Mareeba Shire Council
65 Rankin Street
PO Box 154
Mareeba QLD 4880

**Response to Pre-Request for Information
2-4 Quill Street, Mareeba (OPW/21/0006)**

QUILL STREET LAND DEVELOPMENT

PROJECT REF		CONMAT PTY LTD	
DRAWING REF		QUILL STREET LAND DEVELOPMENT	
DRAWING NO		GENERAL LAYOUT PLAN	
160-001-C103		SIZE	REVISION
		A3	B

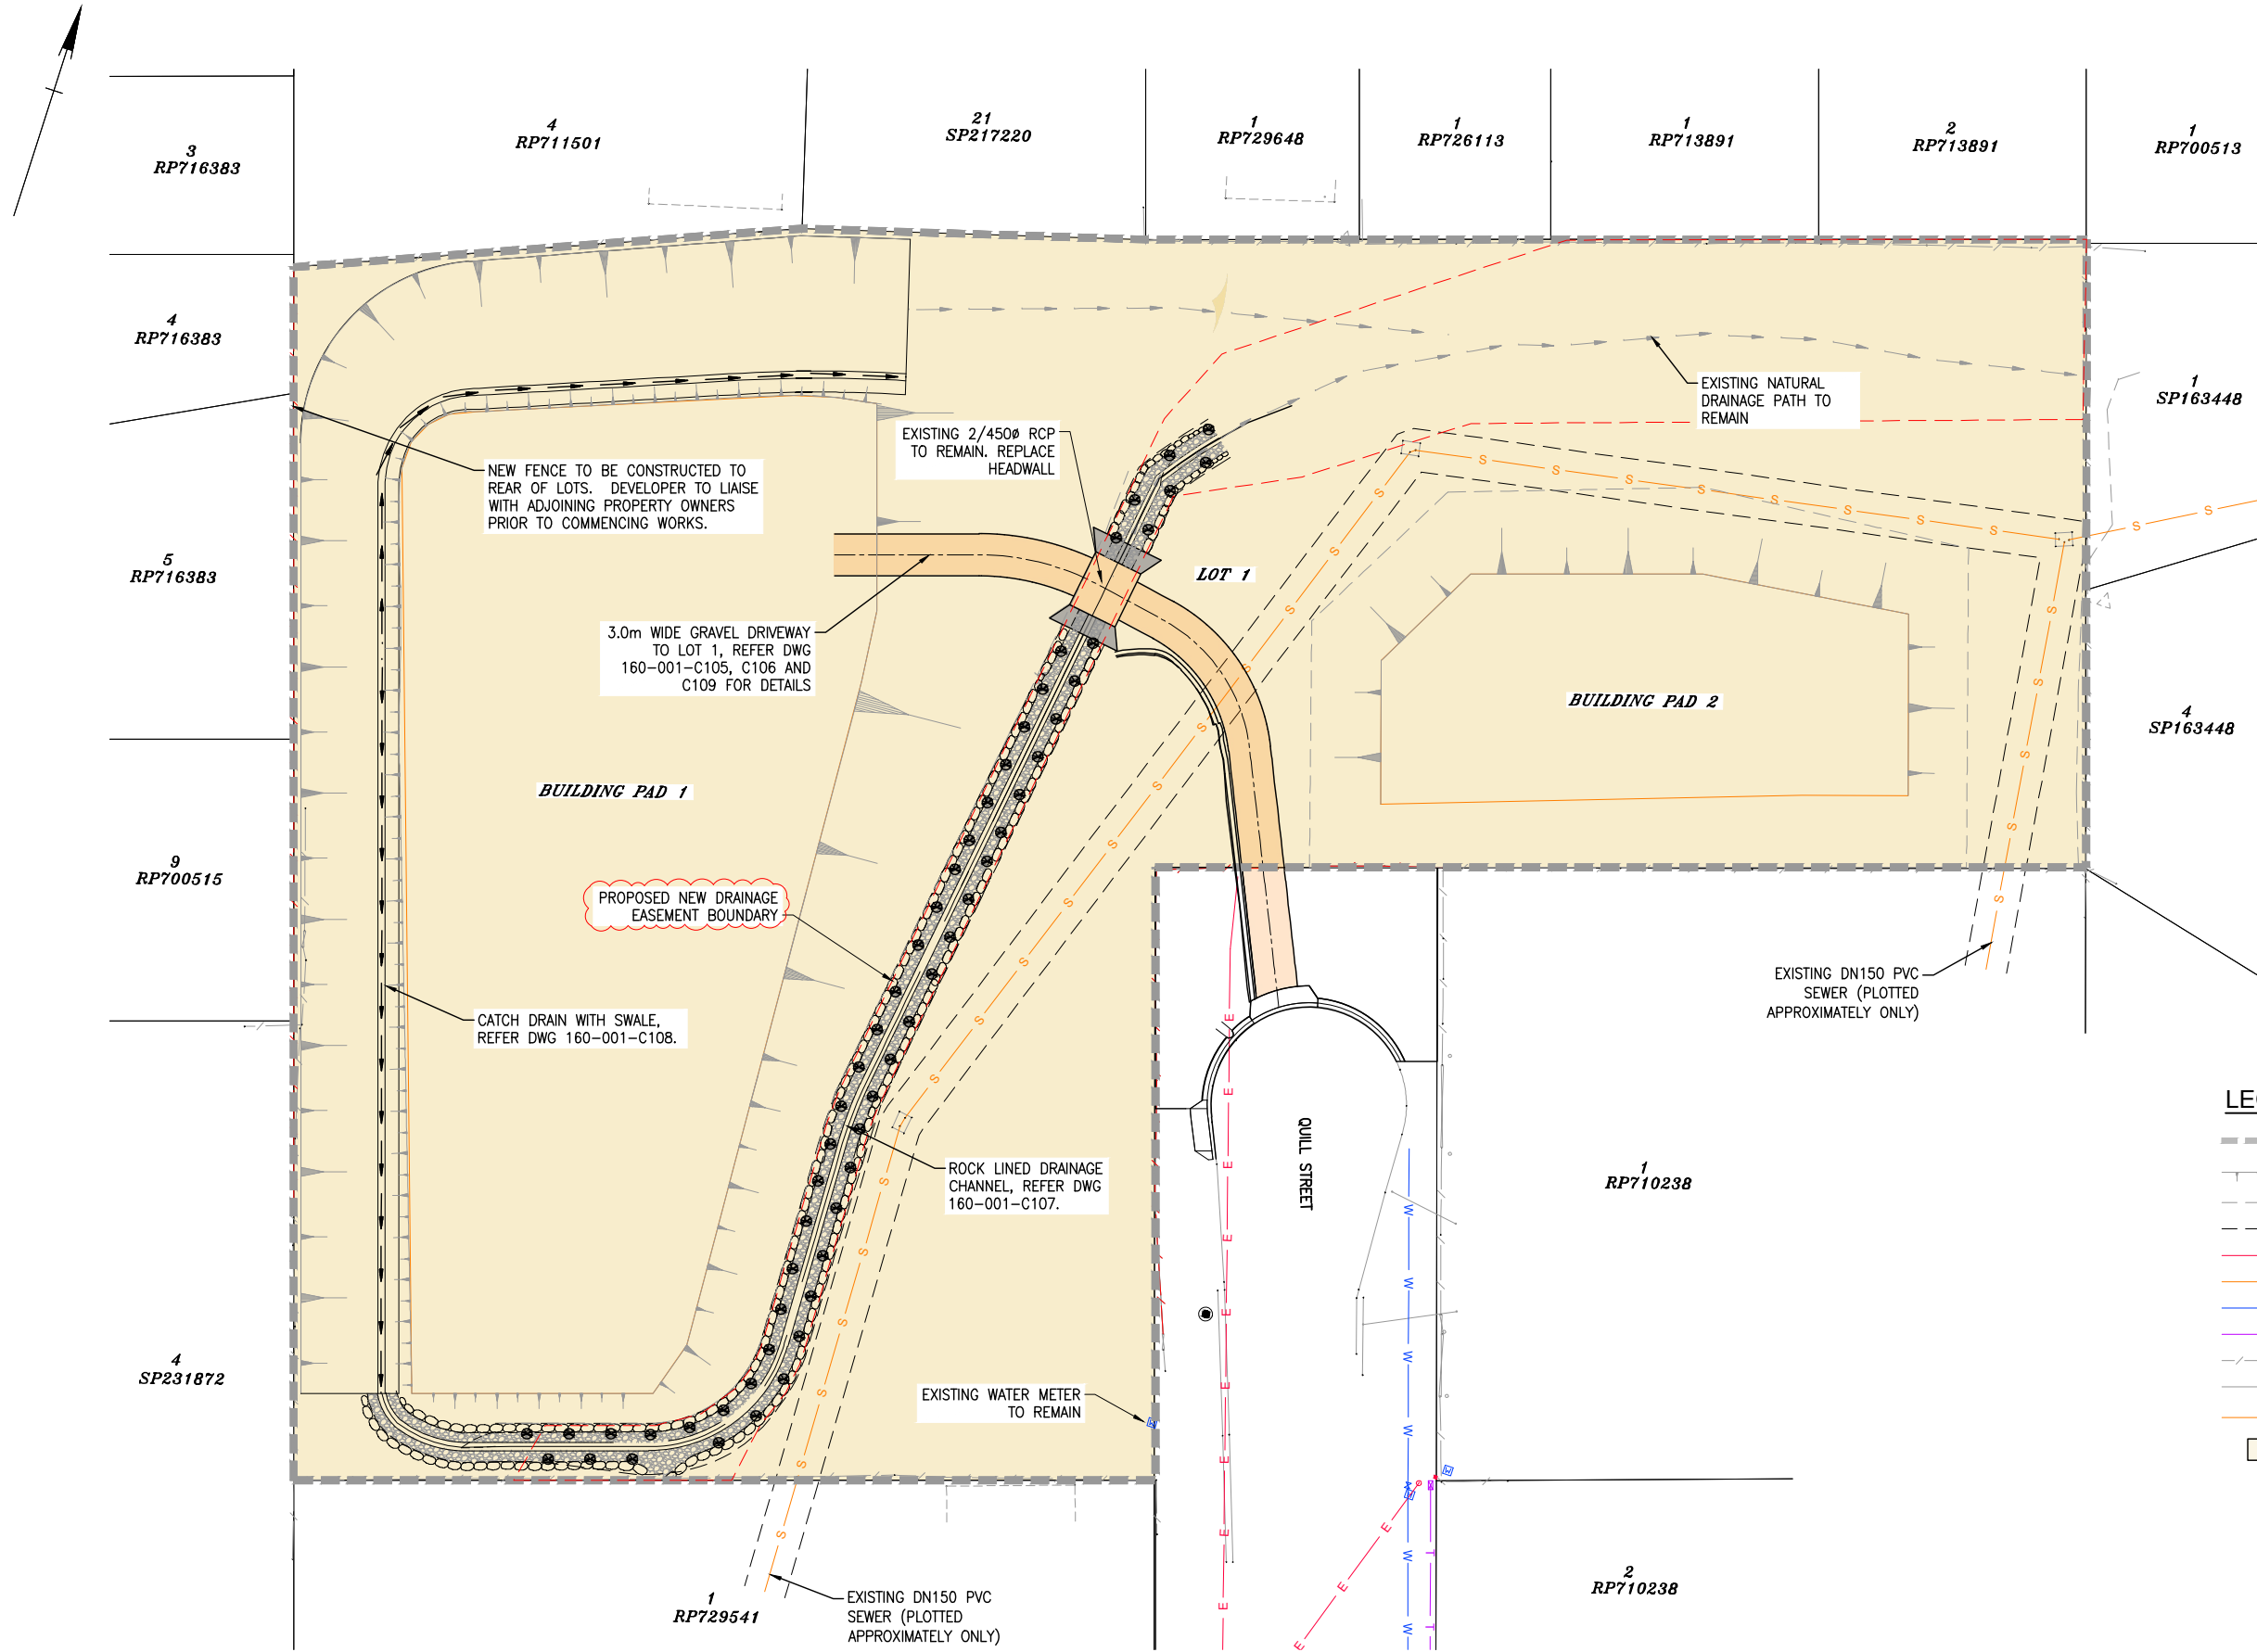
5. The drawings must identify any proposed changes to the drainage easement to reflect the proposed additional drains nominated for construction under this application.

The new alignment of the easement has been shown on sketch drawing 160-001-SK09 rev 1.

PROJECT REF	CONMAT PTY LTD		
	QUILL STREET LAND DEVELOPMENT		
DRAWING REF	GRADING PLAN		
DRAWING NO	160-001-C104	SIZE	A3
		REVISION	A

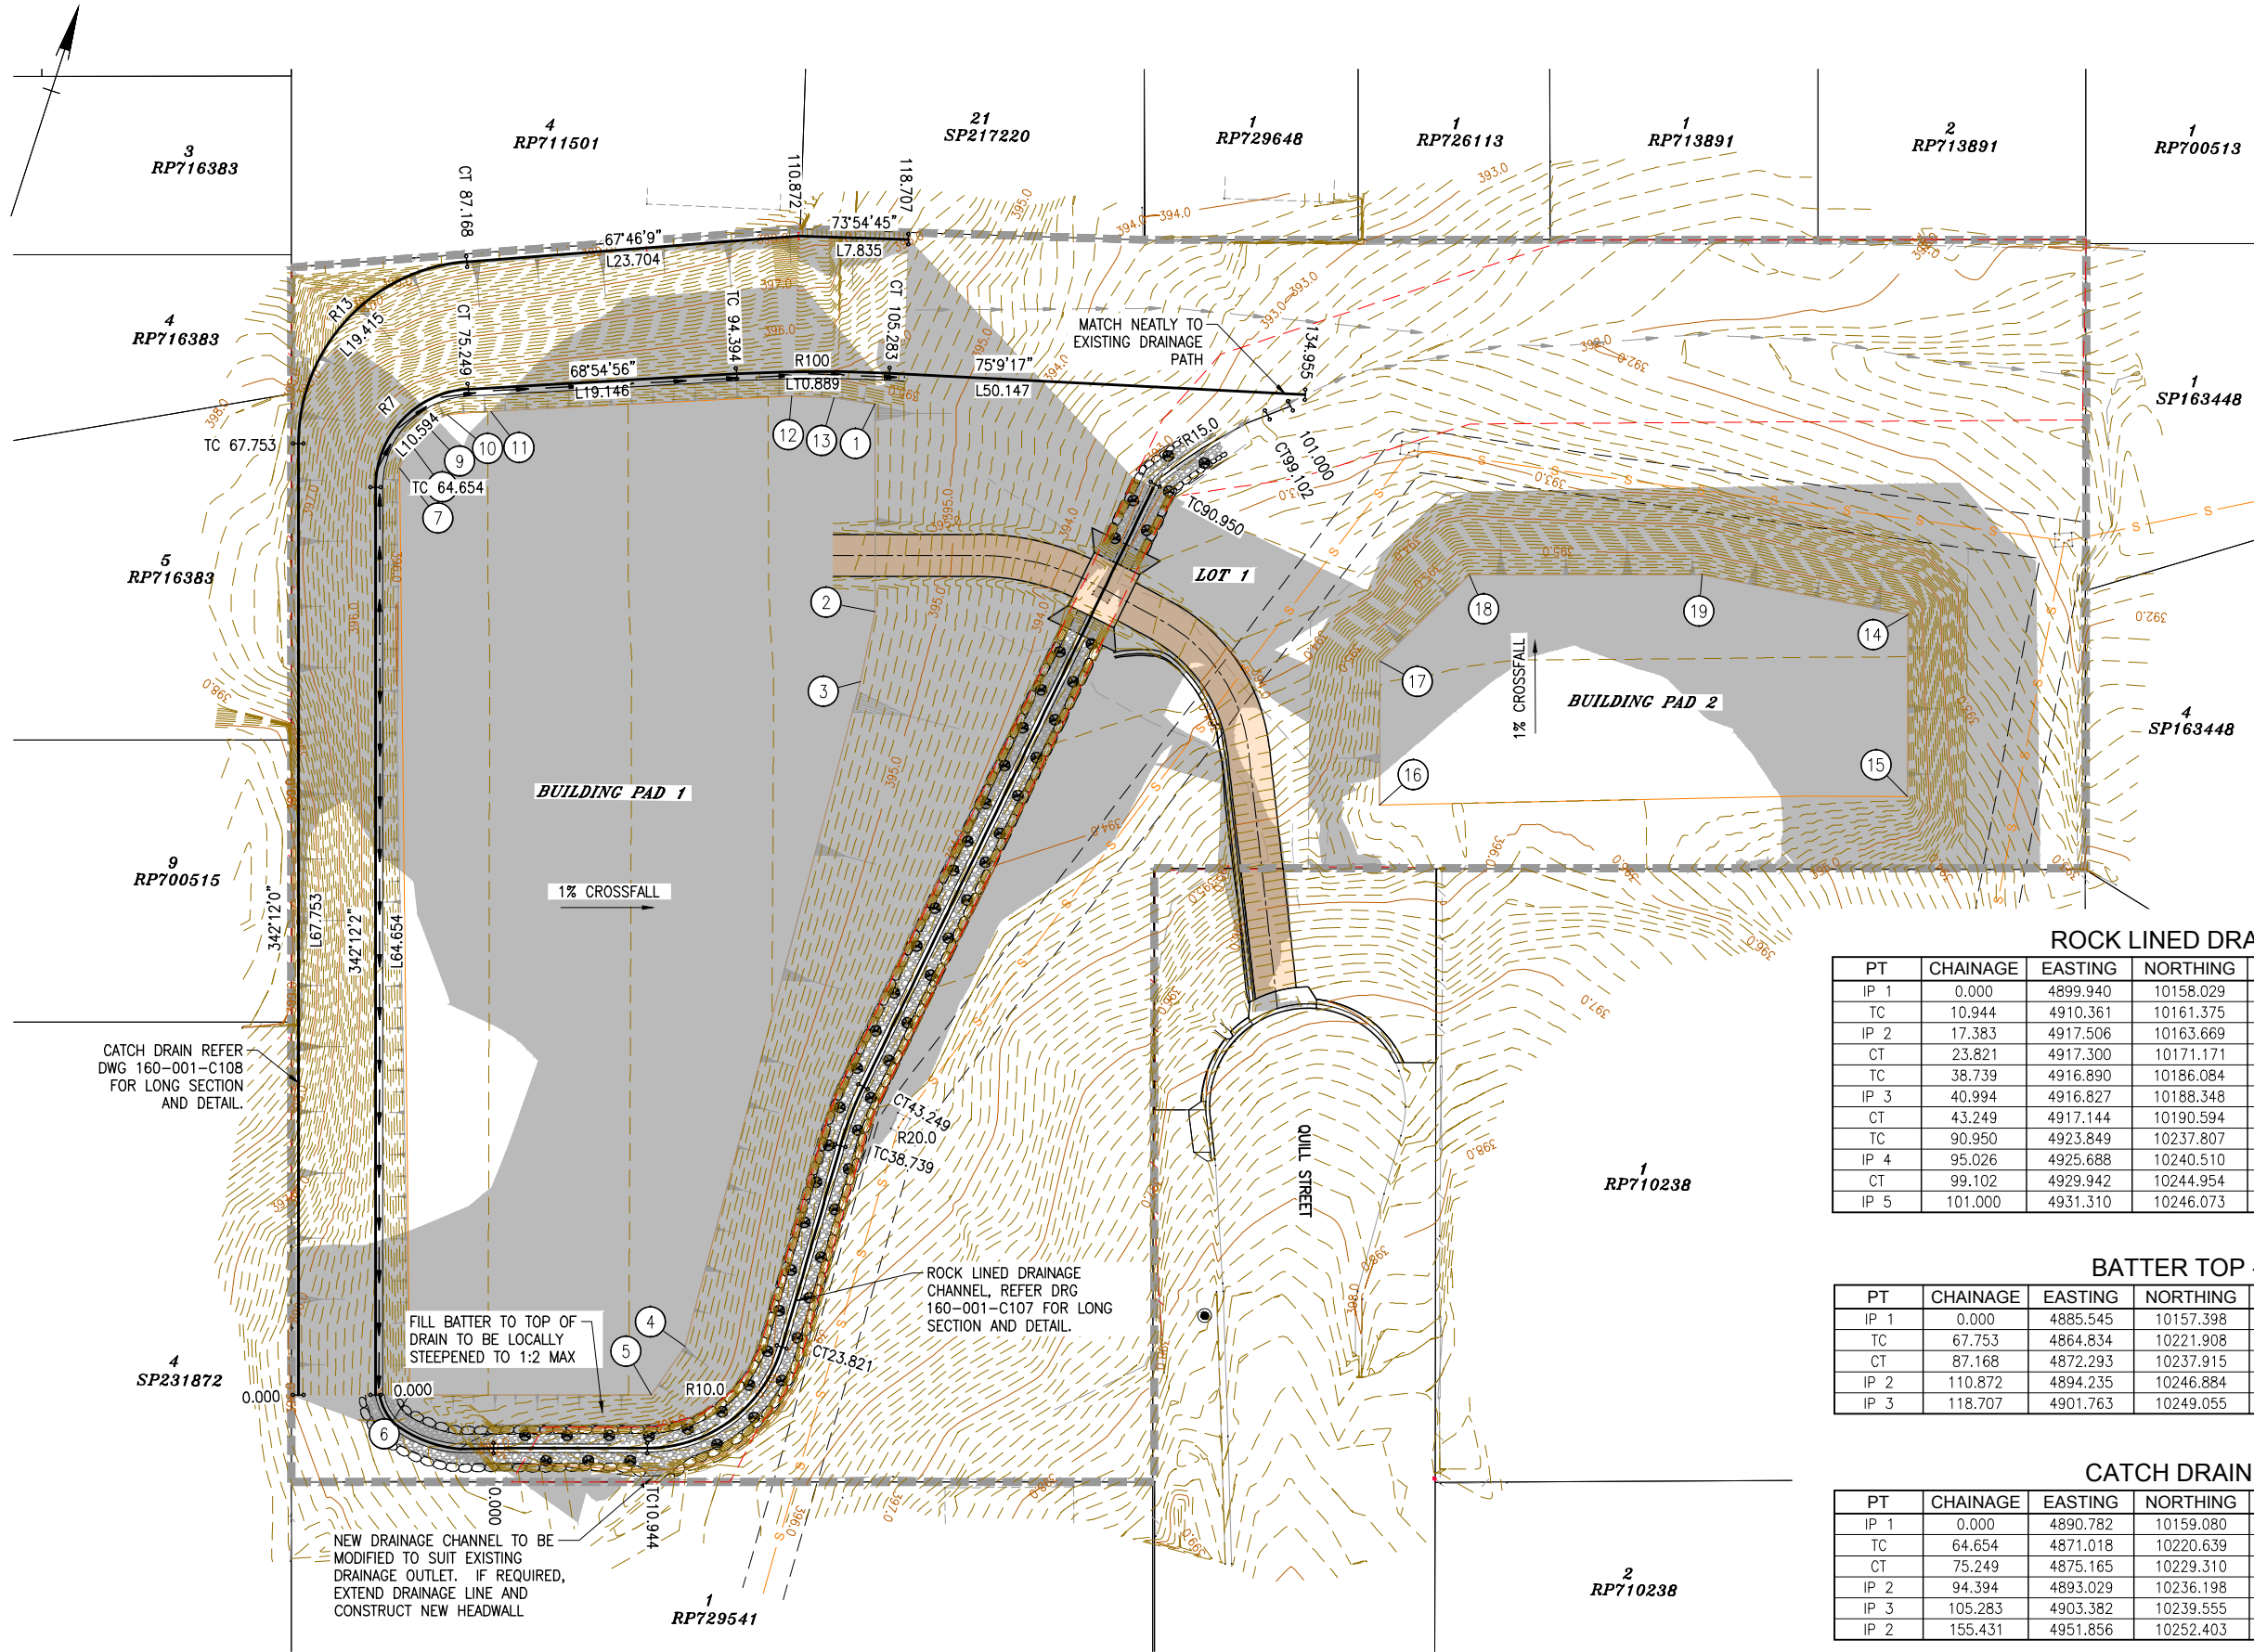
11. Provide additional detail for the interface between the Building Pad 1 Catch Drain and the upstream end of the Rock Lined Drainage channel. The applicant is also requested to confirm the interface details at the downstream end of the rock lined drain. Details of the interfacing are to be included on a localised detail/site grading plan.

Advice Note: Design levels on Drawing C108 suggest there is a drop of approximately 0.5 m from the Catch Drain into the upstream end of the Rock Lined Drain. Additional detail is required to confirm the treatment of the two drains at this interface. At the downstream end of the Rock Lined Drain, existing surface contours are not provided on the general layout plan or the grading plan.

13. The applicant is to confirm the proposed batter slopes adjacent Building Pads 1 and 2, including the western batters into the Catch Drain. The batter slopes are to be labelled on the drawings.

Advice Note: The cross section on Drawing C108 suggests the batter slopes of 16% minimum or one vertical in six horizontal (1v in 6h), but does not include a maximum batter slope. Measuring the distance between contours suggests batter slopes may be as steep as 1v in 1.5h (66%). Batters of this height and slope will require certification as to stability by a Geotechnical Engineer.

I agree the height difference should be the same, however the difference is 70mm. The connection of the grass lined drain into the rock lined drain will be arranged on site. Extra rock will be included in the transition. A detail will be included on the plans at RFI stage.

A geotechnical engineer will be engaged prior to excavation to determine batter suitability and advice. Crossfalls will be included on plans at RFI submission.
